Access Compliance Report

Public Rights-of-Way

(Curb Ramps)

Intersection ID: 23090	Main Street: CHALYCE_LN	Cross Street: LYNBRIDGE_DR	Location: NW
ADA ID: C32D6D83A2D8	Ramp Type: BlendTrans2	Initial Pass/Fail: Fail	Overall Compliance: No
		Severity Score: 10

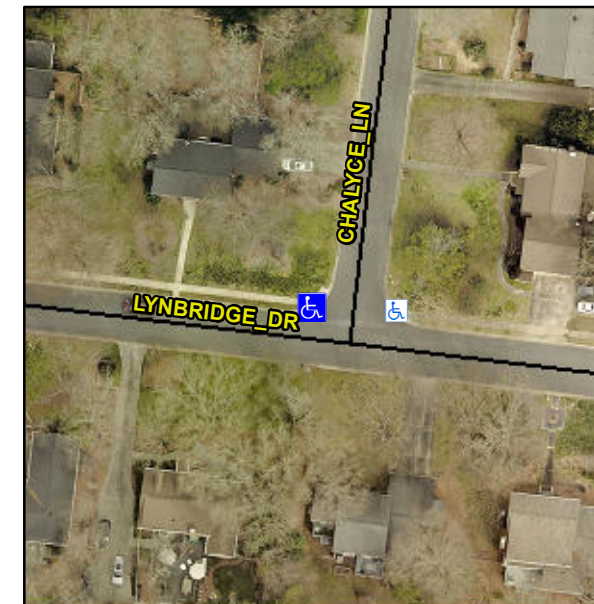
Not Found, R304.5.1, R304.5.3

Compliance	Description	Data	Compliance	Description	Data
N/A	Ramp Length (in)	48.0	Yes	BlendTrans Slope (%)	4.2
No	Ramp Width (in)	39.5	No	BlendTrans XSlope (%)	3.9
N/A	Flare Type LT	N/A	N/A	Flare Type RT	N/A
N/A	Flare Slope LT (%)	N/A	N/A	Flare Slope RT (%)	N/A
N/A	Flare Traversable LT?	N/A	N/A	Flare Traversable RT?	N/A
N/A	Landing Length (in)	N/A	N/A	DWS Provided?	N/A
N/A	Landing Width (in)	N/A	N/A	DWS Contrast?	N/A
N/A	Landing Slope (%)	N/A	N/A	DWS Length (in)	N/A
N/A	Landing X Slope (%)	N/A	N/A	DWS Full Width?	N/A
N/A	Landing Curb? (Y/N)	N/A	N/A	DWS Offset (in)	N/A
N/A	Shared Landing?	N/A			
N/A	Gutter Ponding?	N/A	N/A	Gutter Slope (%)	N/A
N/A	Gutter Lip Ht (in)	N/A	N/A	Gutter X Slope (%)	N/A
N/A	Painted X Walk1?	No	N/A	Painted X Walk2?	No
	X Walk 1 Direction	To S		X Walk 2 Direction	To E
	X Walk 1 Width (in)	N/A		X Walk 2 Width (in)	N/A
	X Walk 1 Slope (%)	0.5		X Walk 2 Slope (%)	3.9
	X Walk 1 X Slope (%)	6.4		X Walk 2 X Slope (%)	1.7

N/A	Ramp inside XWalk1?	N/A	N/A	Ramp inside XWalk2?	N/A
	Road Slope (%)	1.7		Clear Space?	N/A
	Road X Slope (%)	4.2	N/A	Clear Space to XWalk (in)	N/A
N/A	Any Obstructions?	N/A	N/A	Storm Grate/Utility Hazard?	N/A
	Obstruction Type			Storm Grate/Utility Type	
		N/A			N/A
			Yes	Surface Condition? (G/P)	Good
			No	Curb Slope (%)	6.9

Remove & Replace Curb Ramp With Two New Directional Ramps or Equivalent.
